IFB No. IFB No. 22-24 HVAC Upgrades at Lathrop, Spring Creek and Bloom Schools

RE: ADDENDUM NO. 4

**Subject :** Addendum No. 004  
To the Bid Documents For:  
RPS IFB number 22-24  
Spring Creek, Lathrop, & Bloom Elementary  
HVAC Upgrades  
Rockford, Illinois

Sheet Title:  
MECHANICAL DETAILS

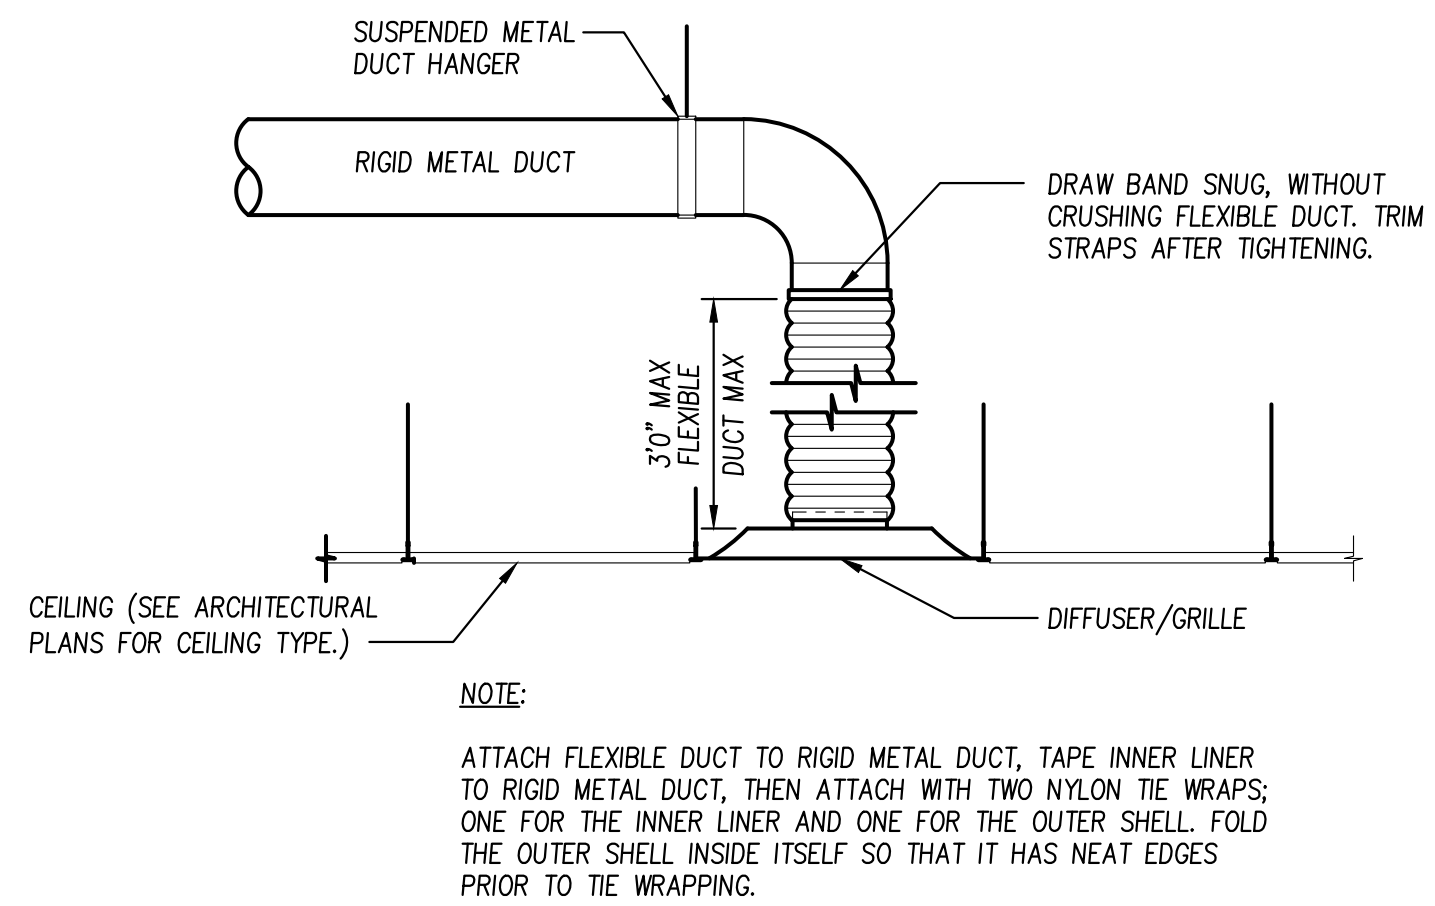
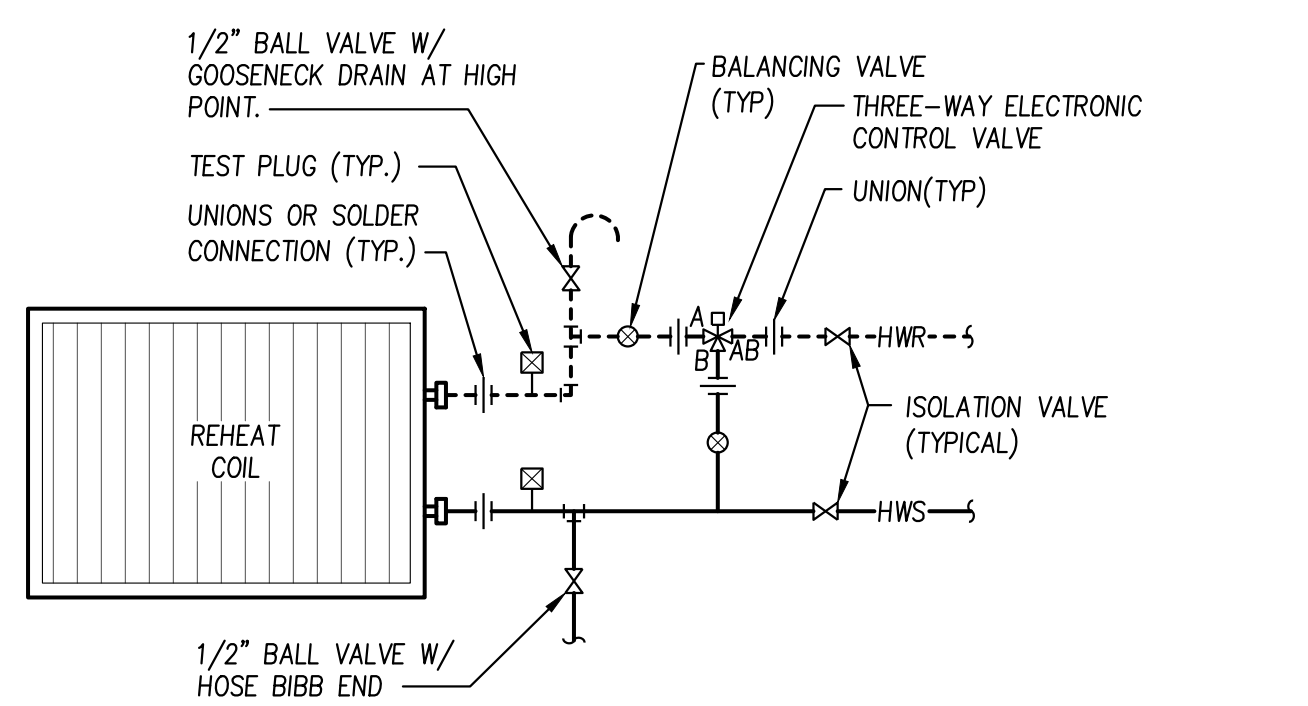
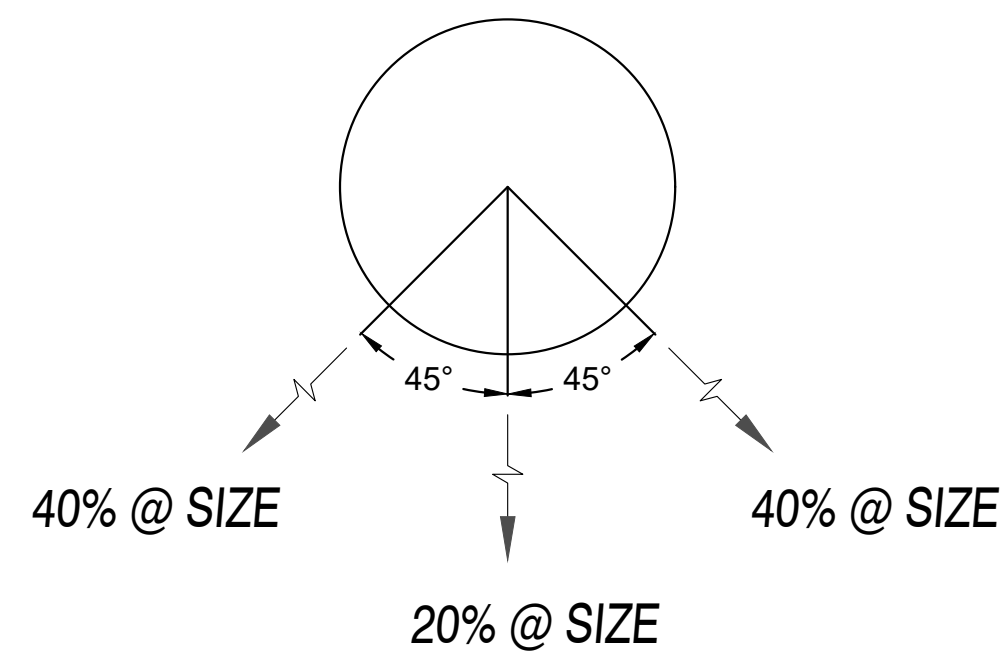
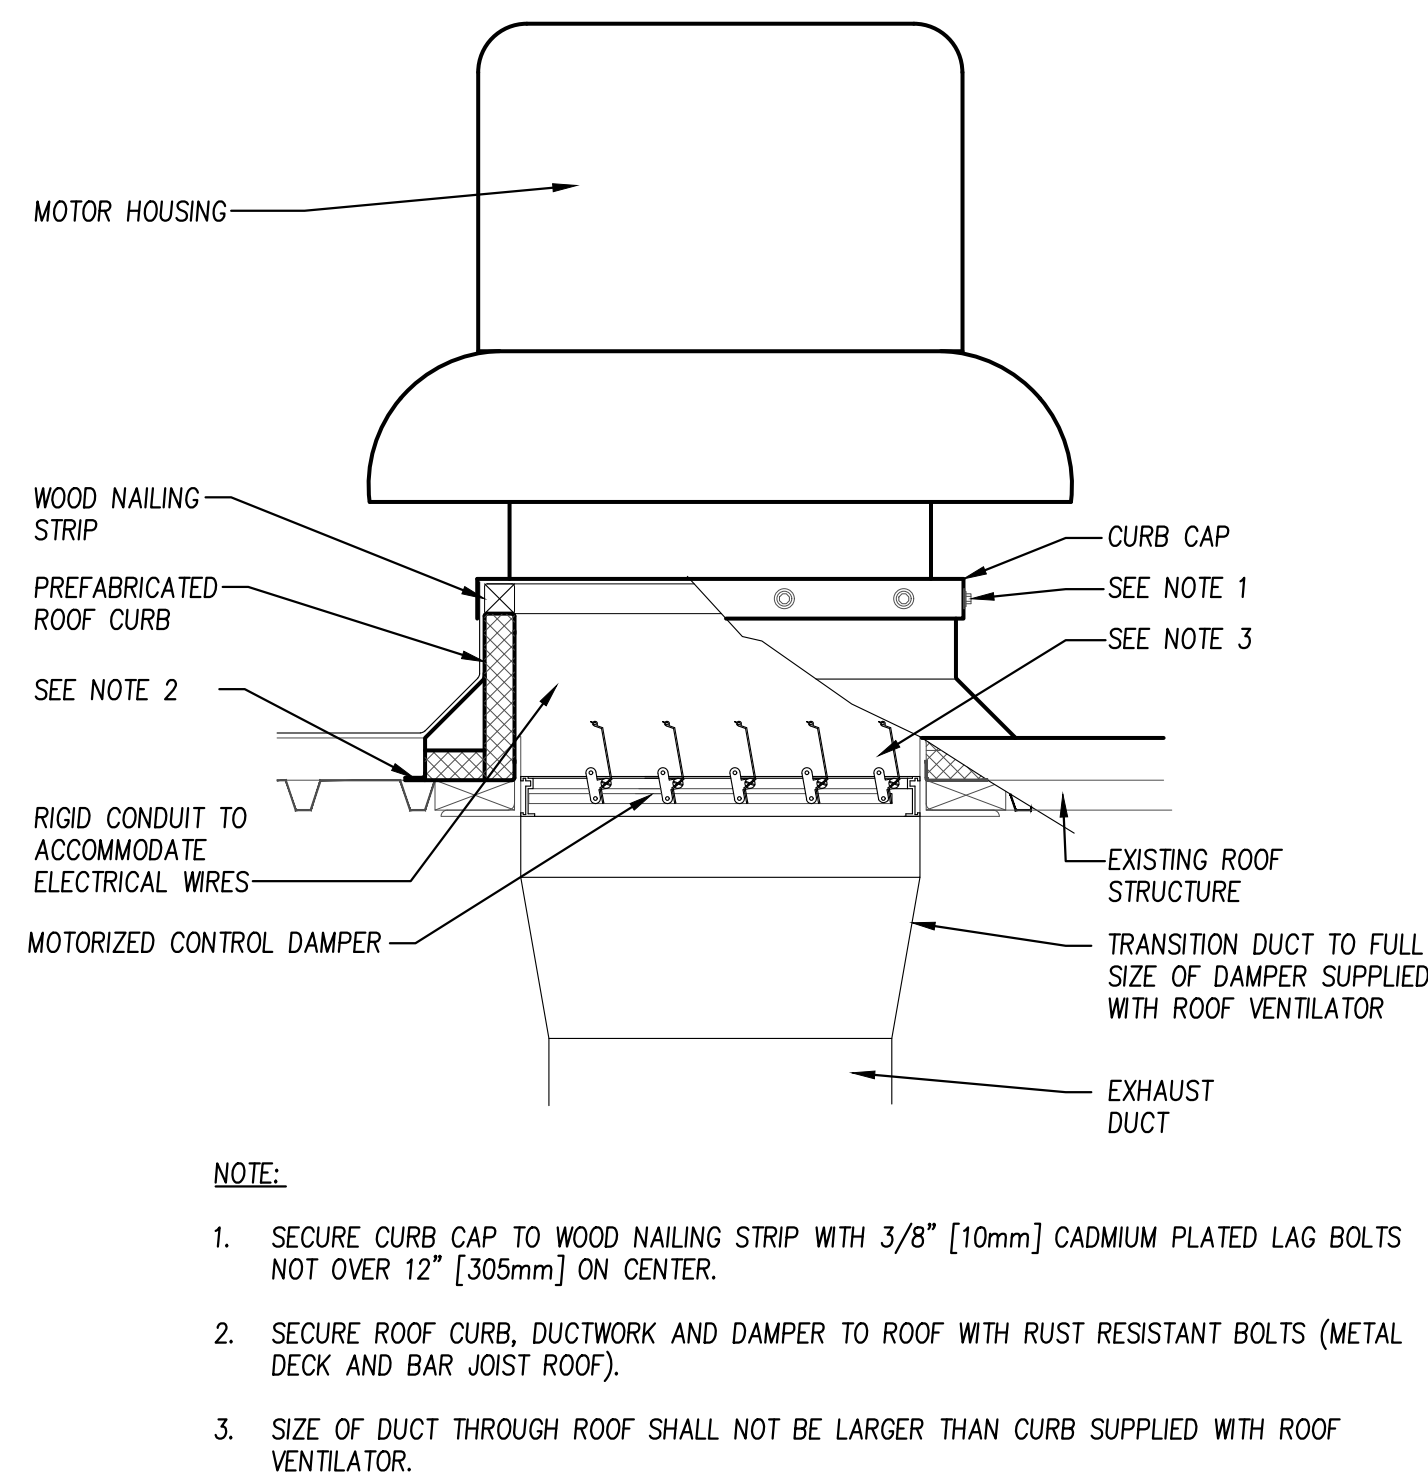
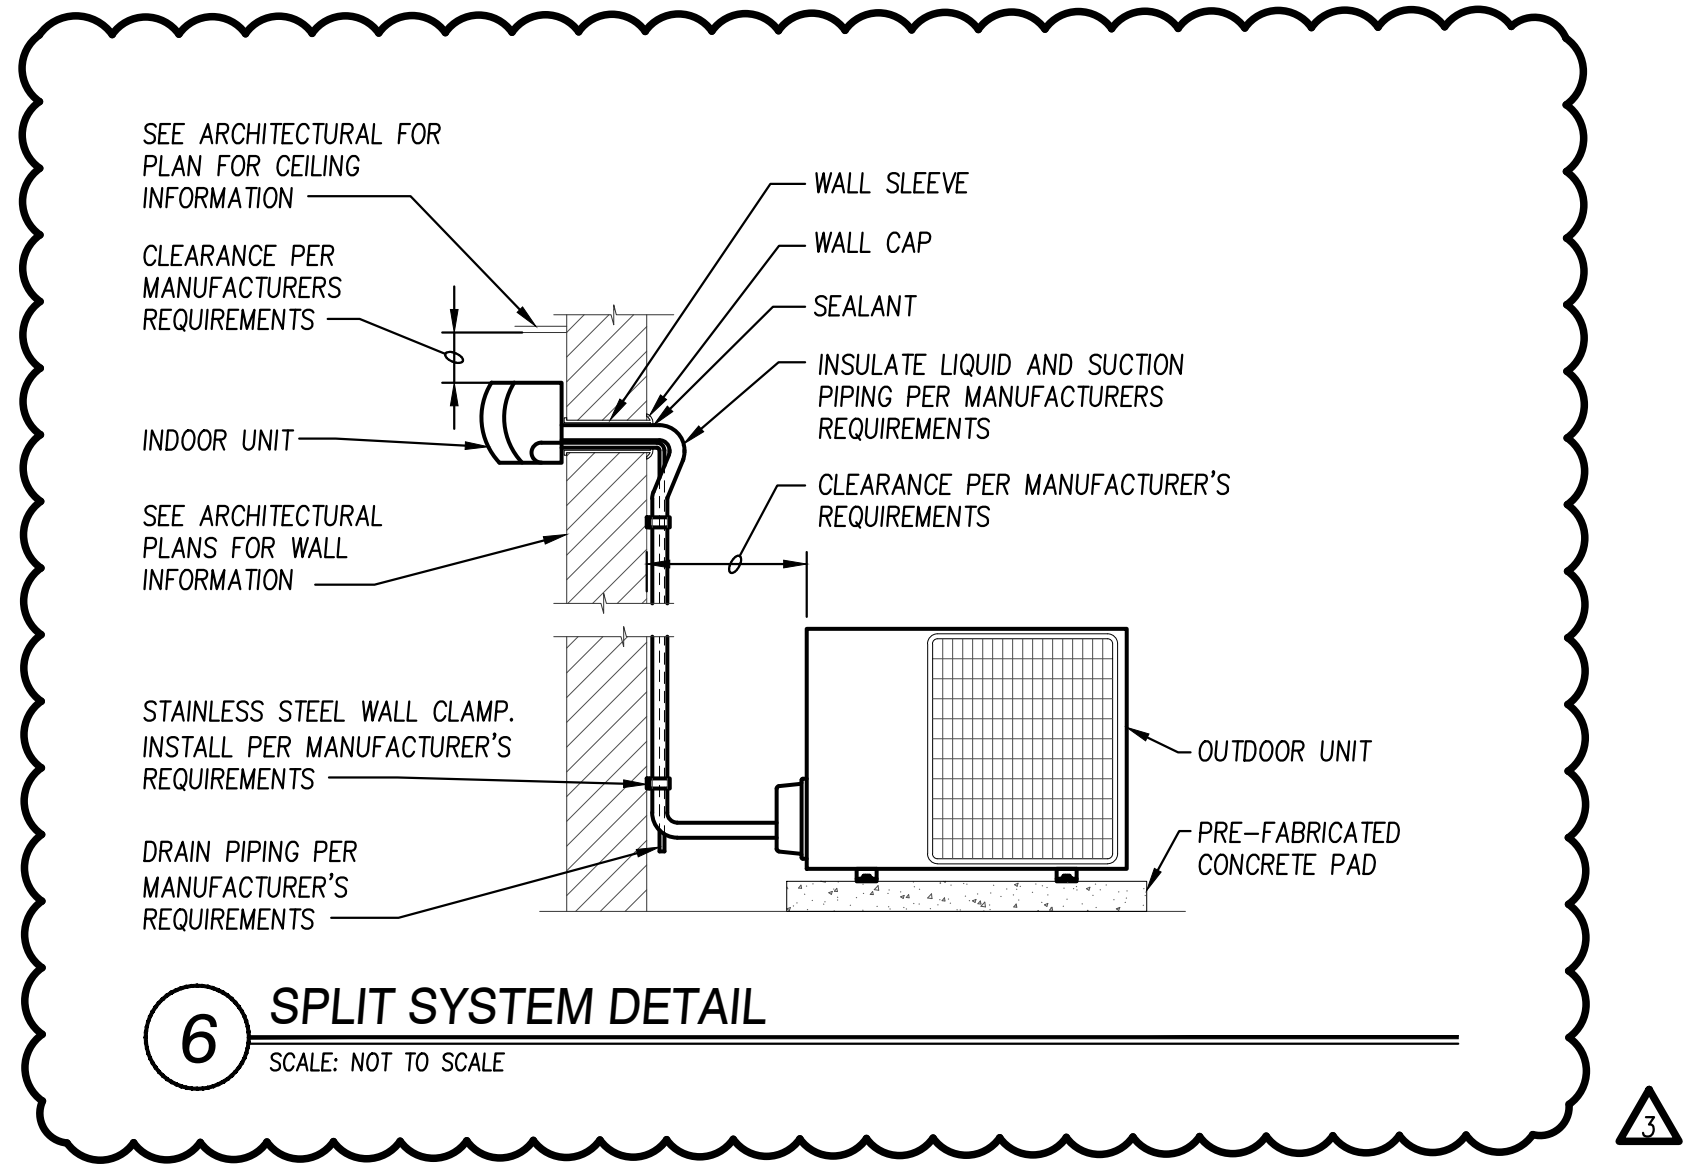
9. Drawing M400 – Mechanical Details
  - a. Add new detail 6 for Split System Unit Installation. See attached sheet M400.
10. Drawing M501 – Mechanical Schedules

Proj. No.: 2248  
Date: 02/18/2022  
Drawn: AEC  
Approved: RCR  
Sheet No.: M501

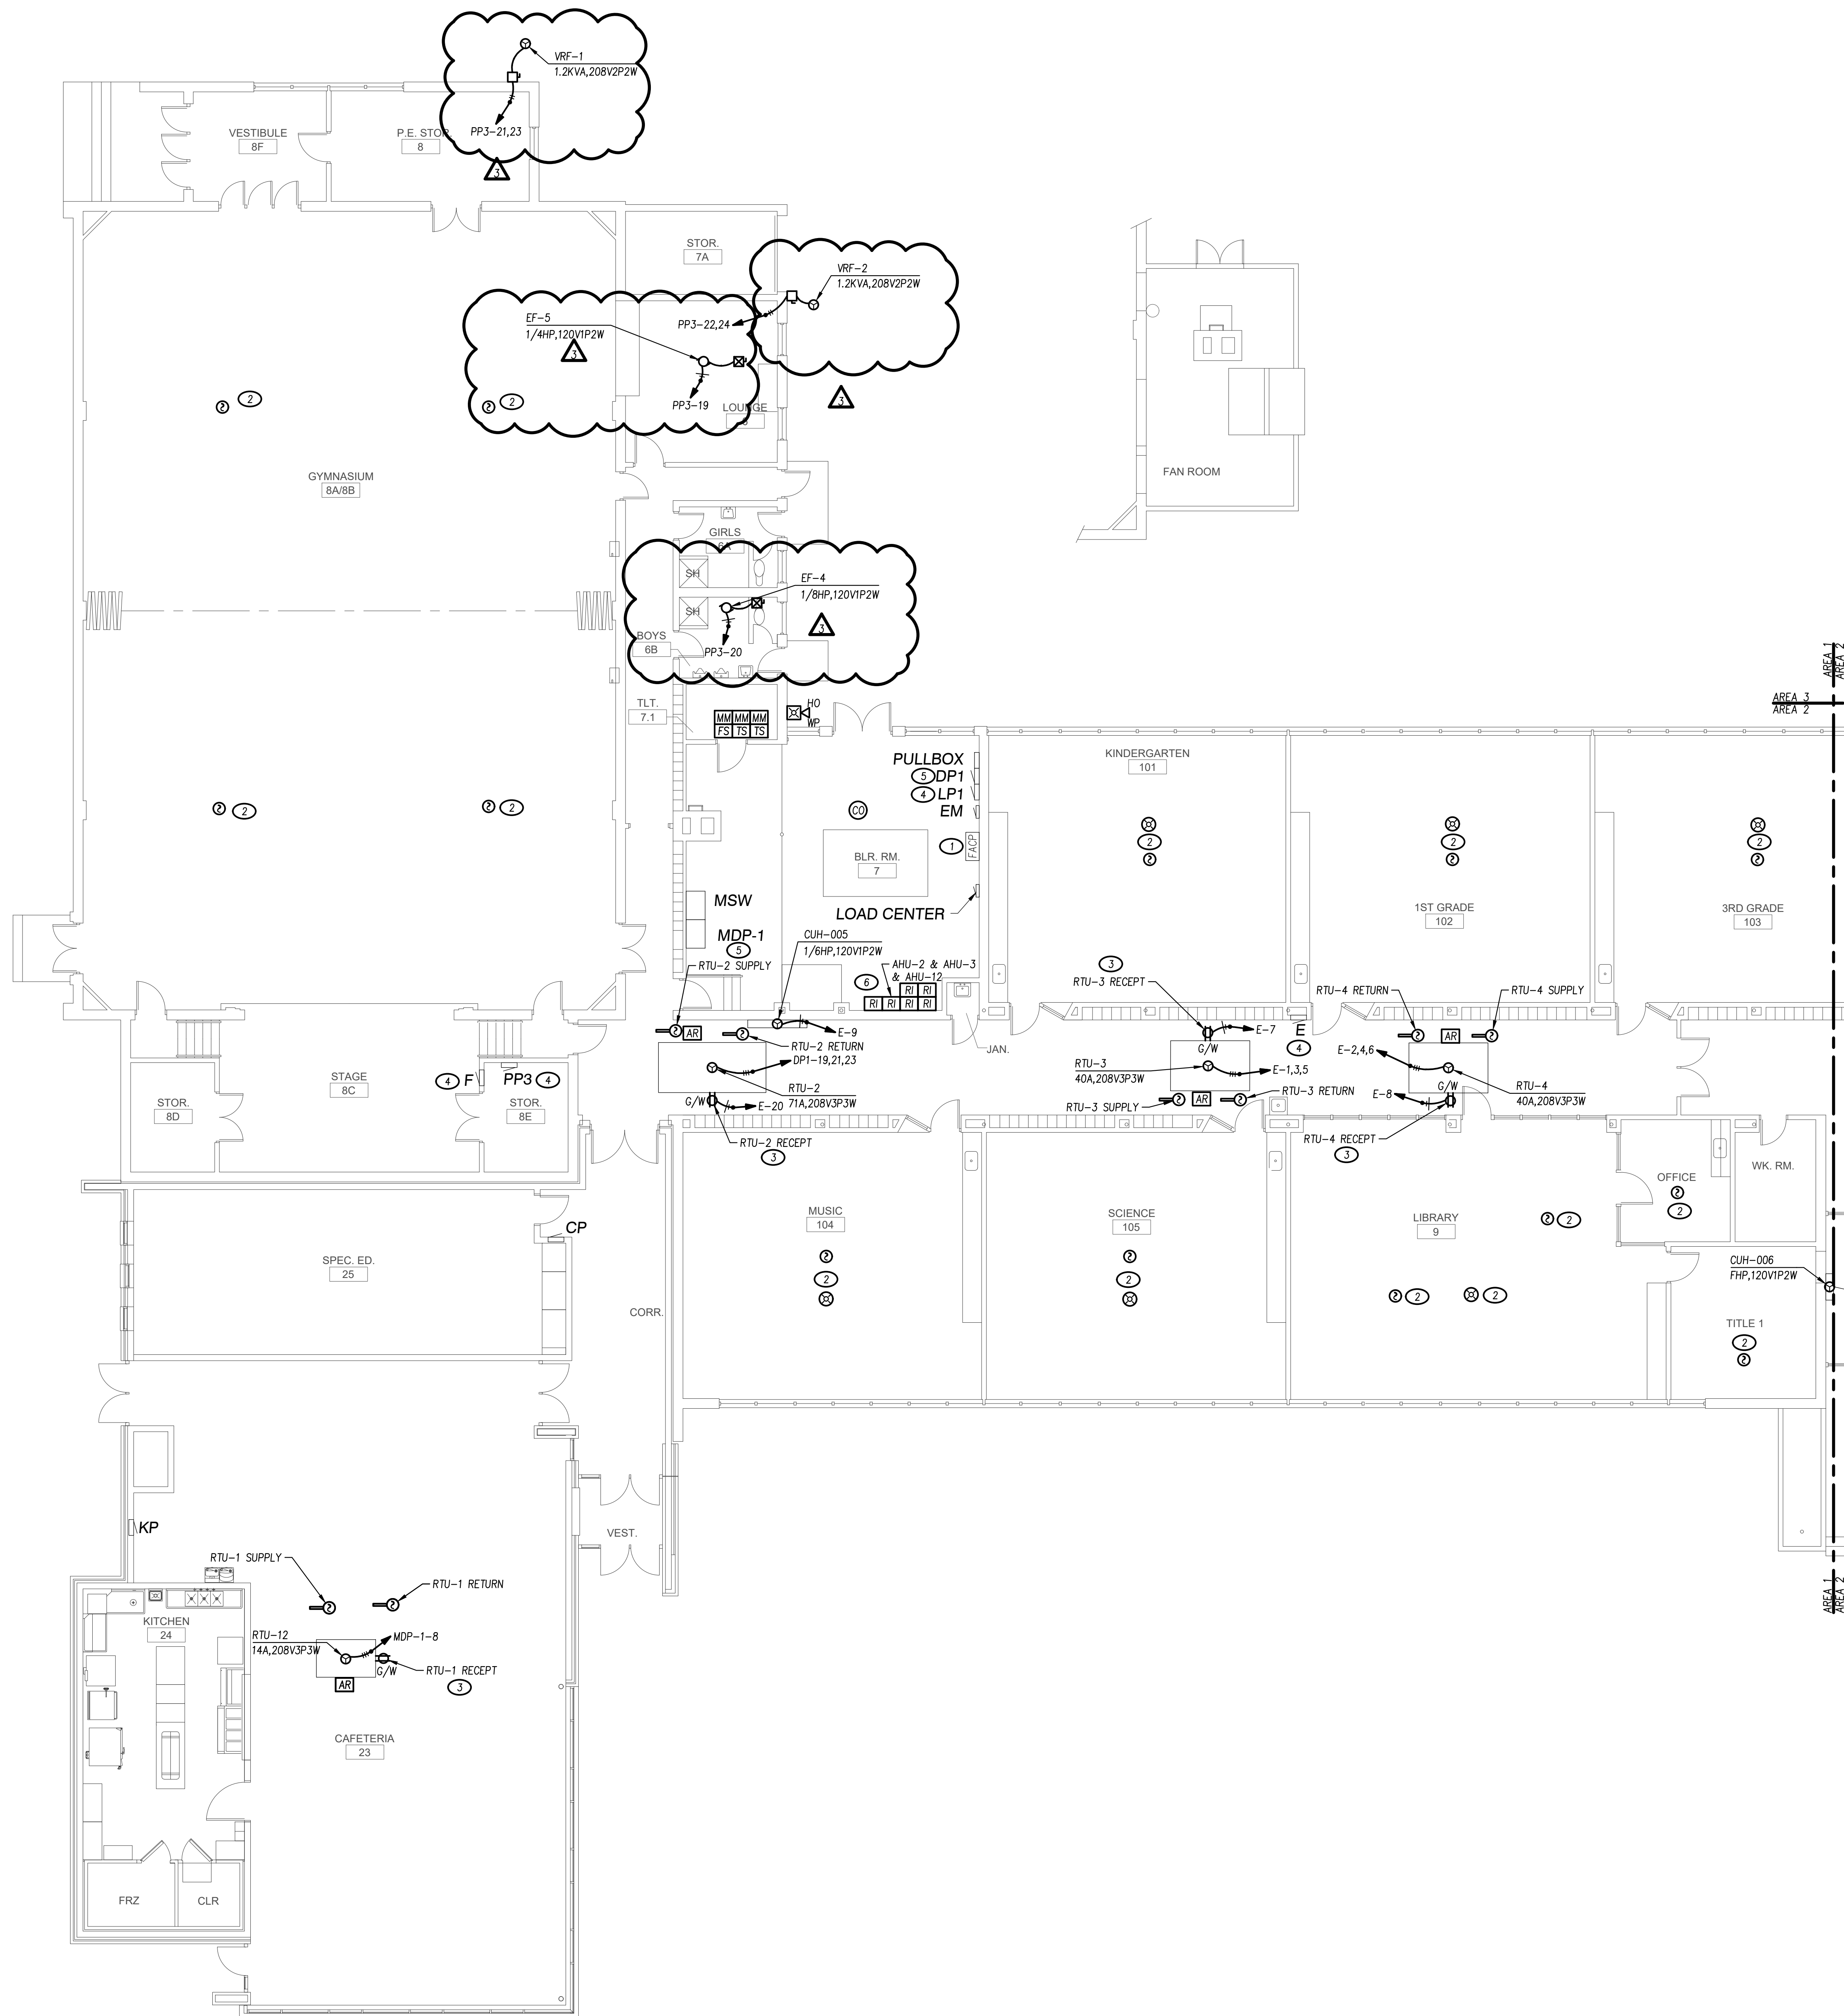
- a. Add new Split-System Air-Conditioning Unit Schedule as shown on attached sheet M501.
11. Drawing E111L – First Floor Plan – Electrical New Lighting – Area 1
